Product/Process Change Notice (PCN)

PCN #: ConUSB_20150909
 Product Affected: 614008235023
 PCN Date: September 23th, 2015
 Effective Date: December 23th, 2015
 Contact: Product Management
 Tel: +49 7942 945-5001
 Fax: +49 7942 945-5179
 E-mail: PCN.eican@we-online.de

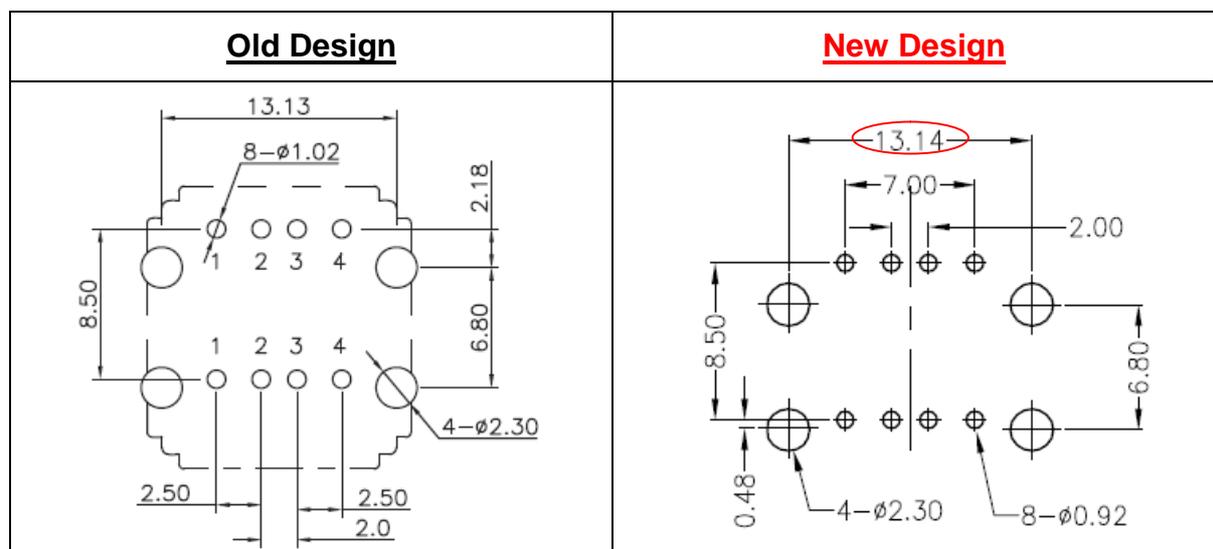
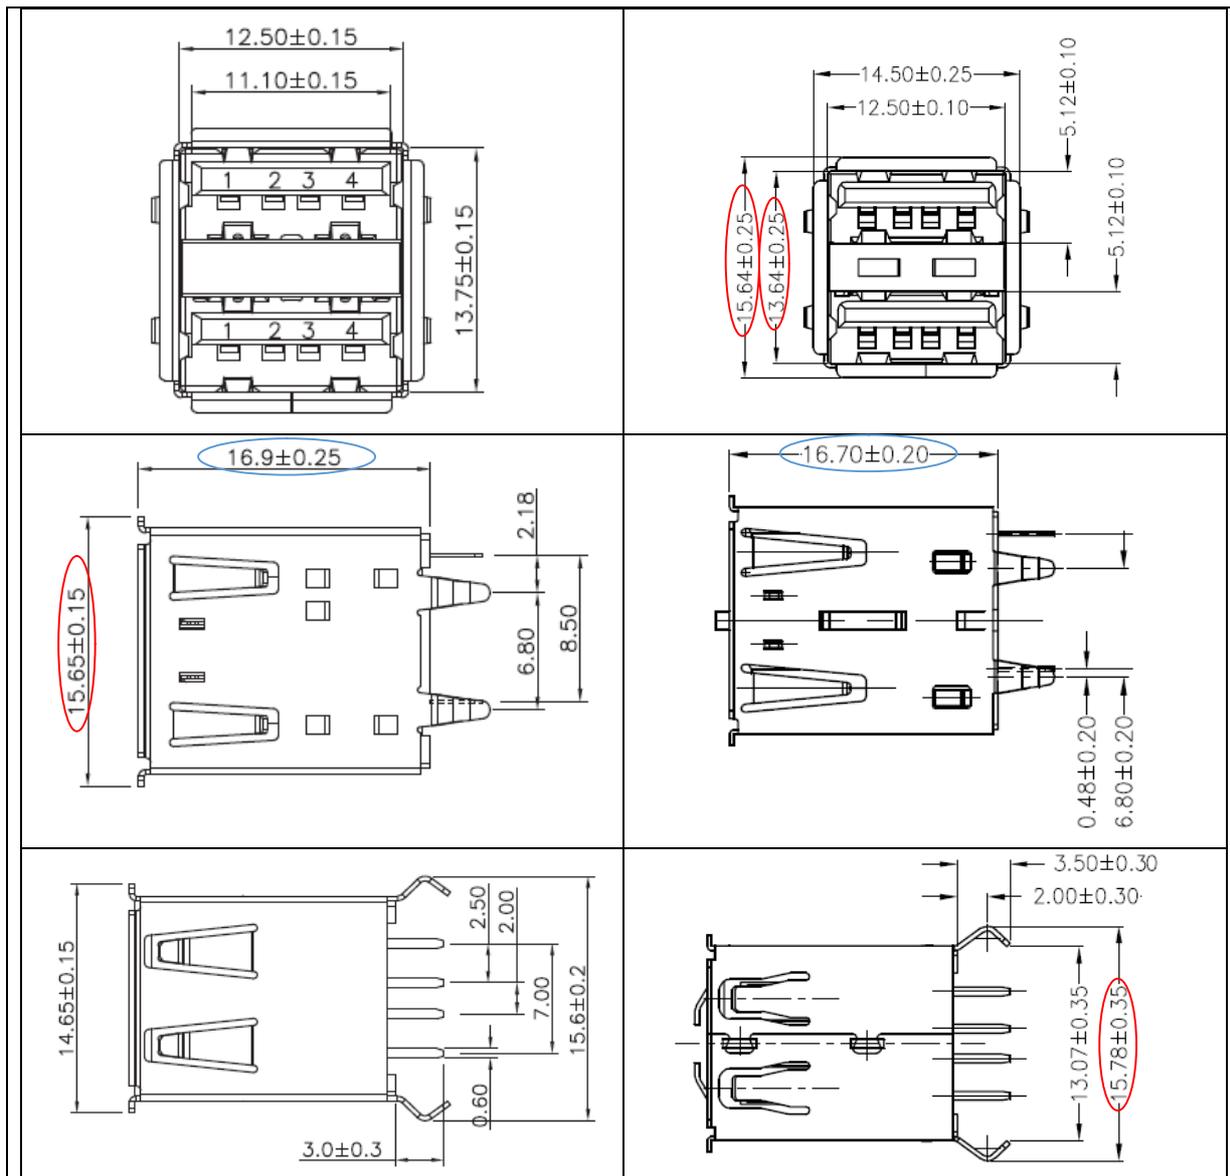
A fully automatized process will be implemented and CCD inspection controls will be added.
 The design changes are summarized below and marked in red / blue:
